Exhibit A - Appellants

Executive Summary

Dark Sky Lighting Standard And Visual Character of Rural Area MCC 39.6850, MCC 37.7710, MCC 39.7735 (B) (2)

VIEW ALTERING CELL TOWER CONSTRUCTION ON WOODARD ROAD

All photos below taken at 150 ft above ground, height of the proposed cell tower.

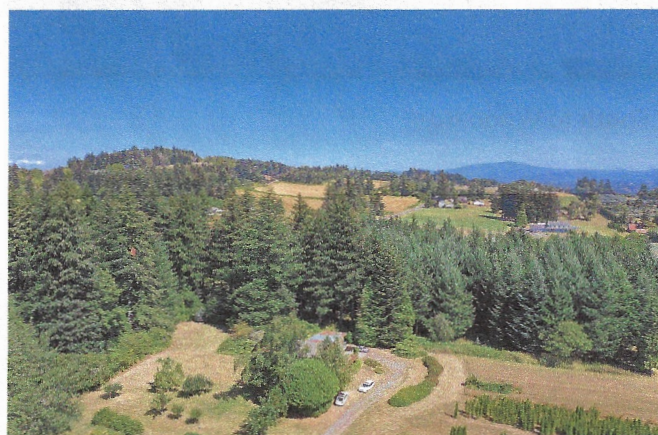
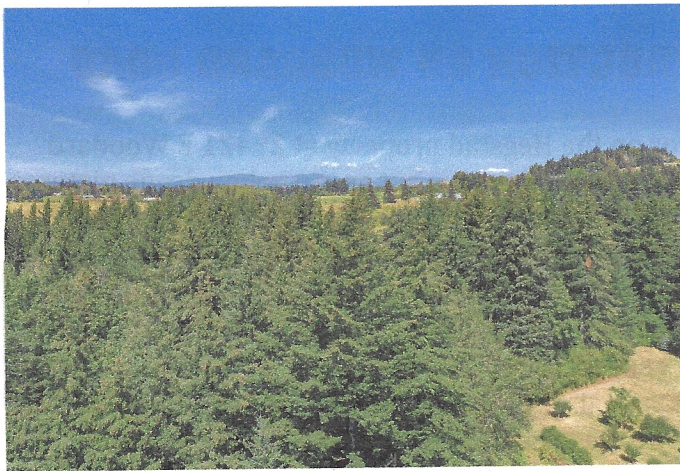
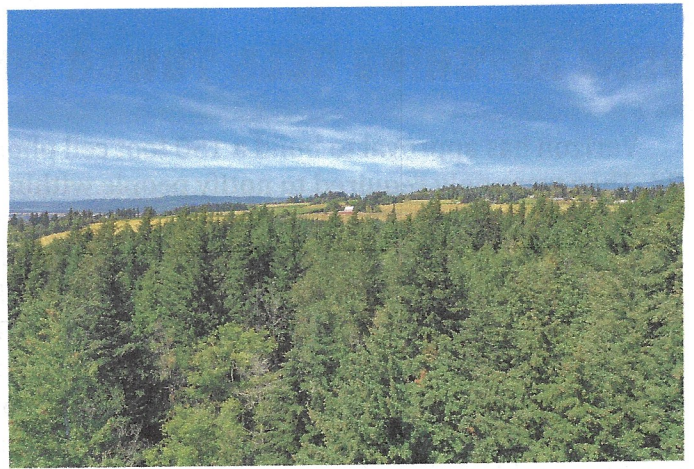
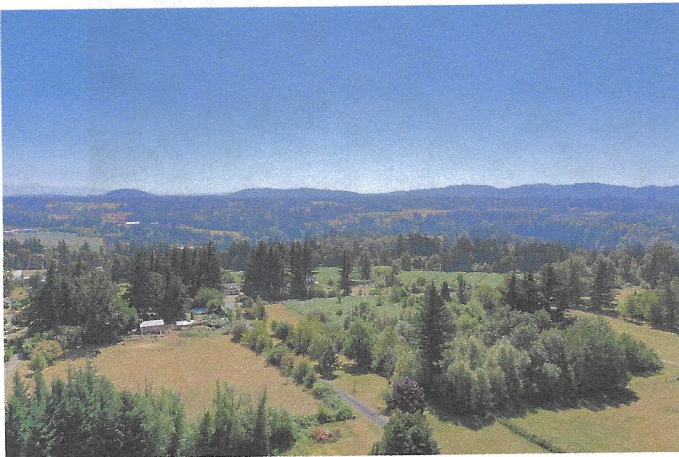
MAK1 – Drone pictures that show distinction between urban area west of the Sandy River versus rural area east of the Sandy River in addition to drone photos at 150' showing clearly how visible the cell tower with flashing lights will be.

Note: Urban area west of Sandy River V.S.
rural area east of Sandy River
clear demarcation that needs to be protected.

Exhibit Mark

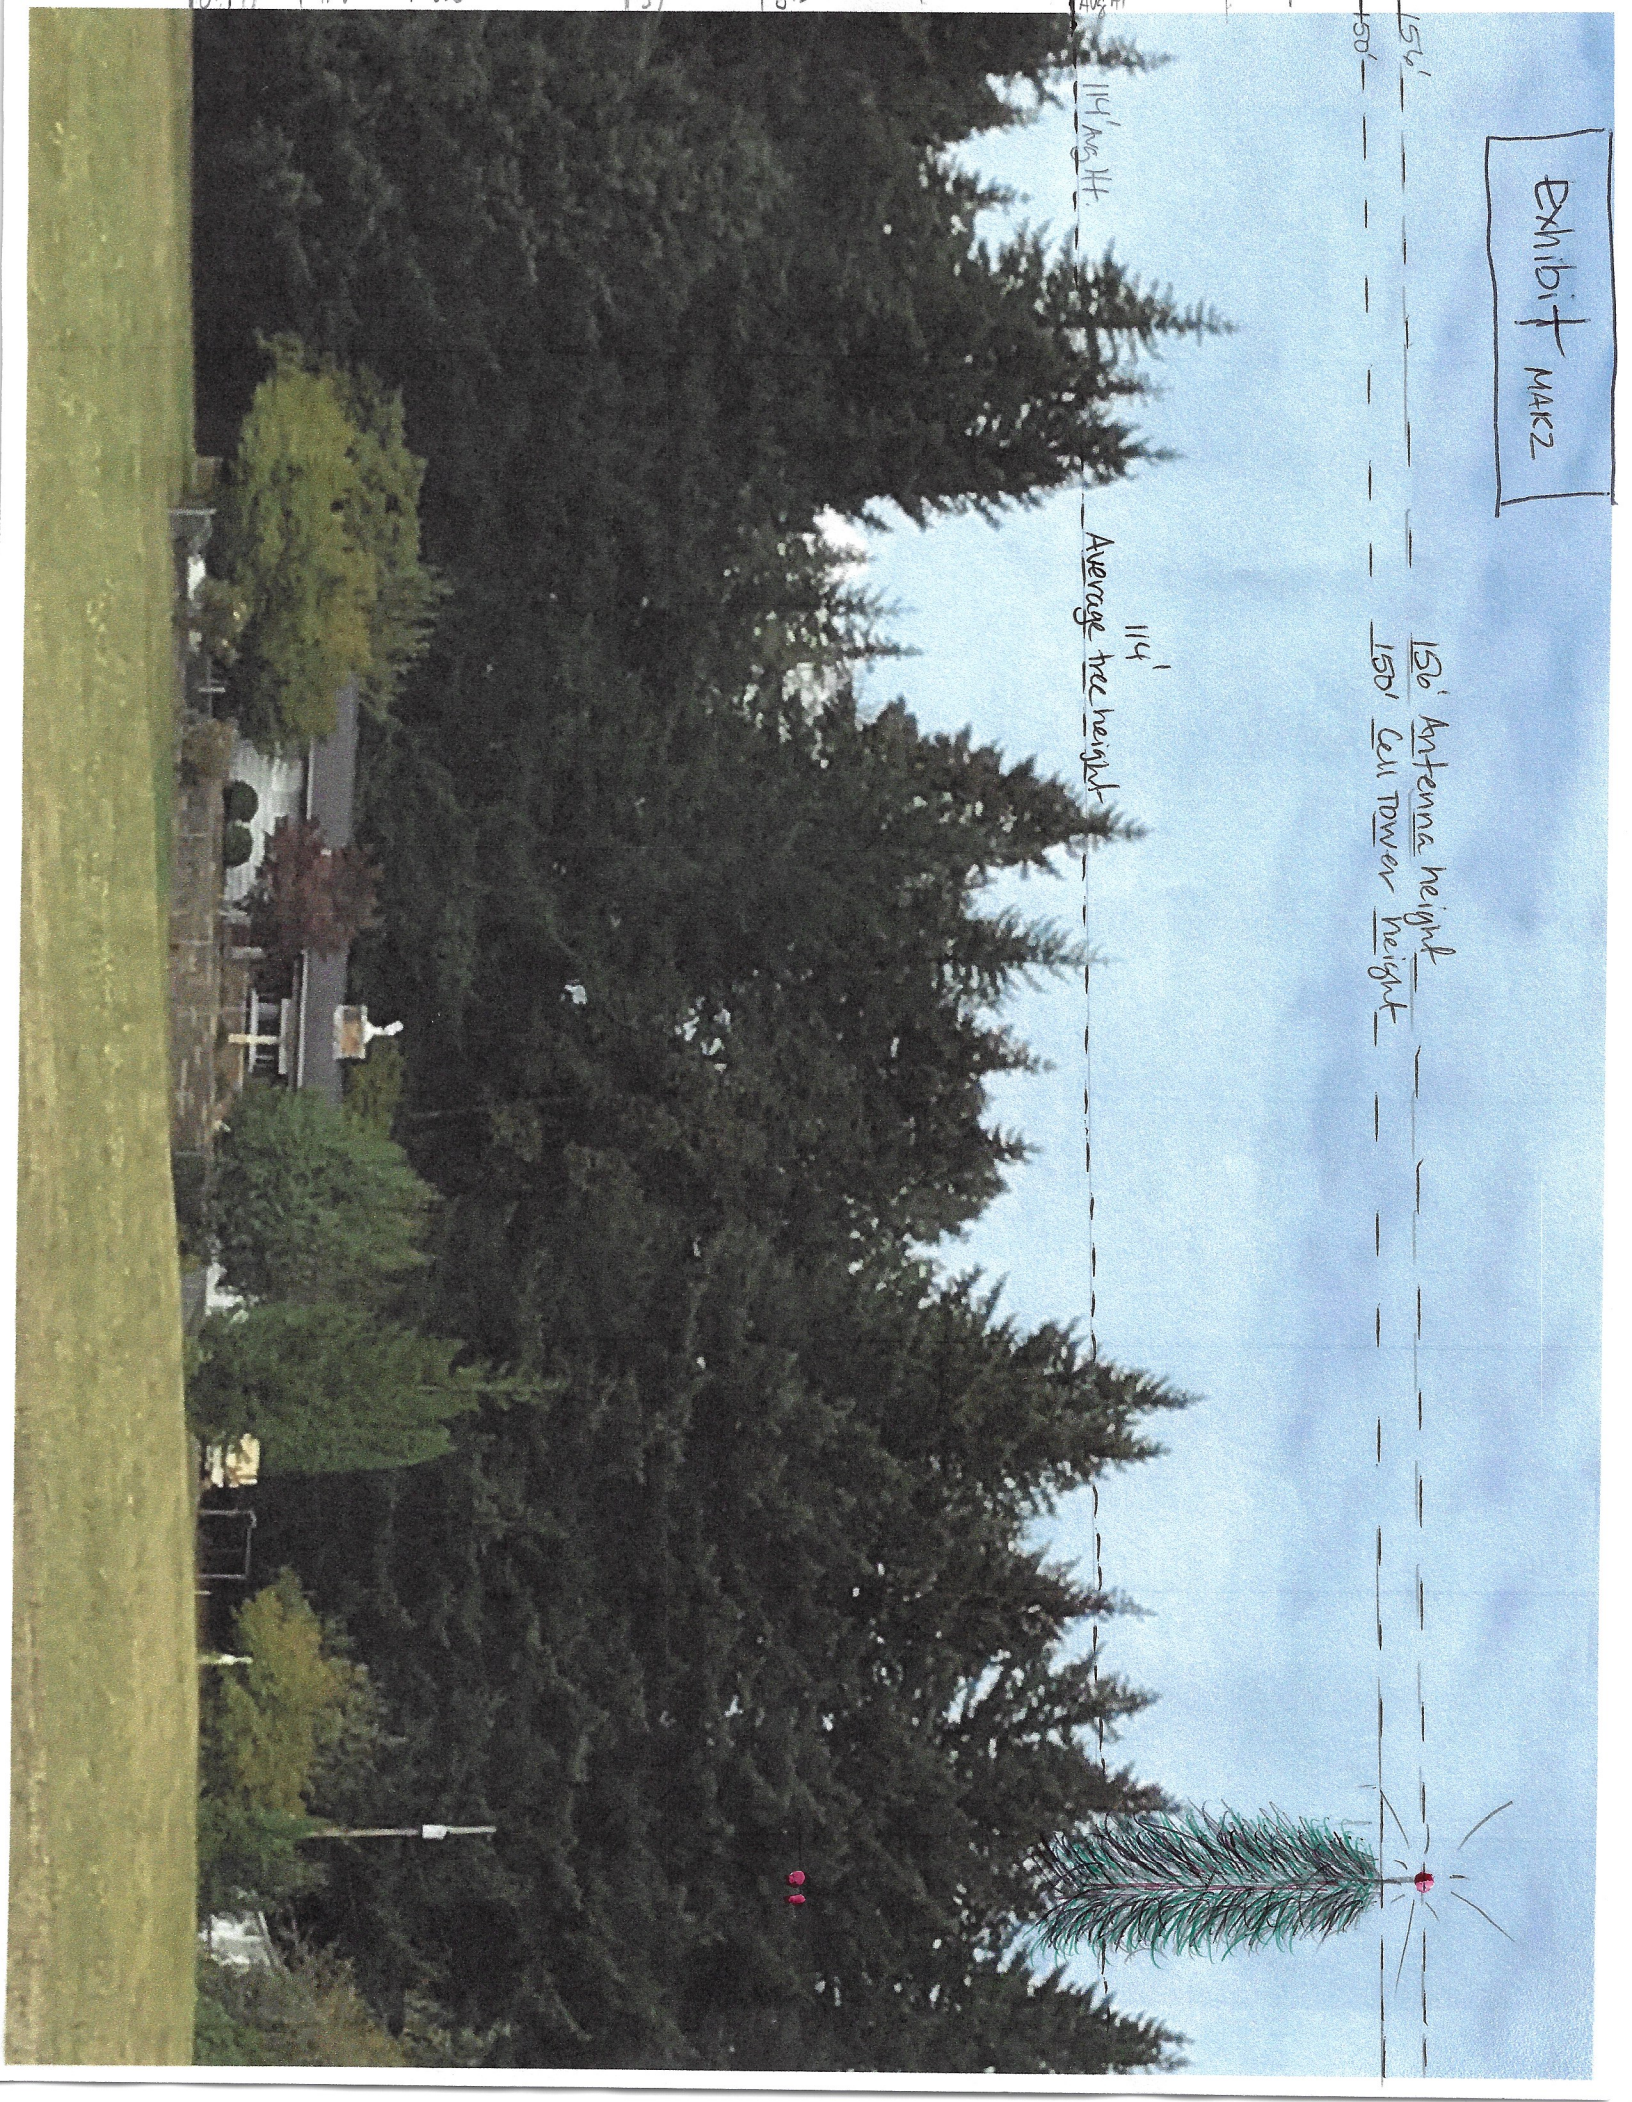
The proposed Cell tower is designed to be 150' plus an additional 6' antenna for a total of 156'. The Douglas fir trees in this area according to US Department of Agriculture are an "Interior variety of Douglas fir and do not attain the growth rates, dimensions, or age of the coastal variety. Interior Douglas fir reach an average height of 100-to 120'." The Douglas fir in the area of proposed cell tower have an average height of 114' and will not get much higher than they already are. In contrast, BlackRock noted that Douglas fir reach a height of 175' – clearly **not in agreement** with US Department of Agriculture documented height for interior Douglas firs.

We strongly disagree with BlackRock's opinion that the cell tower will be visually subordinate. With the cell tower protruding 42' higher than the average tree in the surrounding area is one reason the tree will NOT be visually subordinate, but the fact that the cell tower is required to

have FAA marker/obstruction lighting on it at TWO heights will further exacerbates its visual dominance. At the 156' level there will be a continuous flashing white/red FAA marker light with the second light being red marker lights at mid-span. The continuous flashing red/white light will cause the cell tower to be visually dominant and **will not** blend in with surrounding trees. And since this tower protrudes 42' above the surrounding trees with a continuous blinking light, it will as a beacon drawing attention to it. We can't understand the requirement of the second marker light is at mid-span. At mid-span, it puts the lights well below the average height of surrounding trees. Again, it will noticeably contrast with surrounding landscape and is NOT subordinate. Because FAA flashing marker lights will be on the cell tower, it ultimately is not in compliance with **MCC 39.6850, MCC 39.7700 (A) (B), MCC 39.7710.**

156' Antenna height
150' Cell tower height

114' avg Ht.

114'
Average tree height

VIEW #1 LOOKING NORTH
AT 29421 E. WOODARD RD.

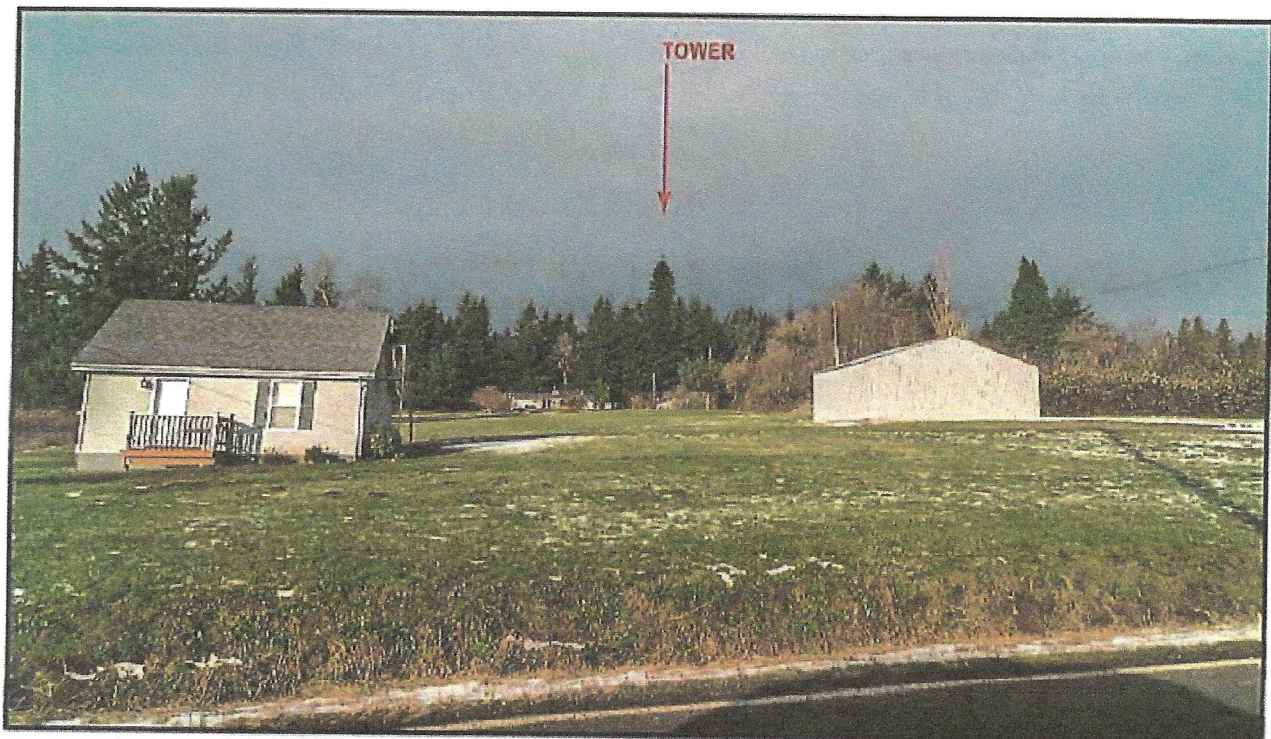
In addition, MCLU received a visual study from BlackRock LLC with only pictures of the cell tower from different sites within a 5 mile radius during the day and not what the cell tower will actually look like in reality with continuous flashing FAA marker lights day and night. **MCC 39.7735** states to show graphic simulation of the appearance of the facility that ensures that various potential views are represented. The visual study **fails to show** in reality what the cell tower will actually look like with continuous flashing lights day and night. **The study submitted by BlackRock to MCLU does not show these potential views.**

The visual study did not represent all potential views. It was only a comparison of before and after pictures at different locations around the neighborhood during daylight. It was unsuccessful at showing all potential views to include flashing red/white FAA marker lights and how obtrusive they will be both day and night.
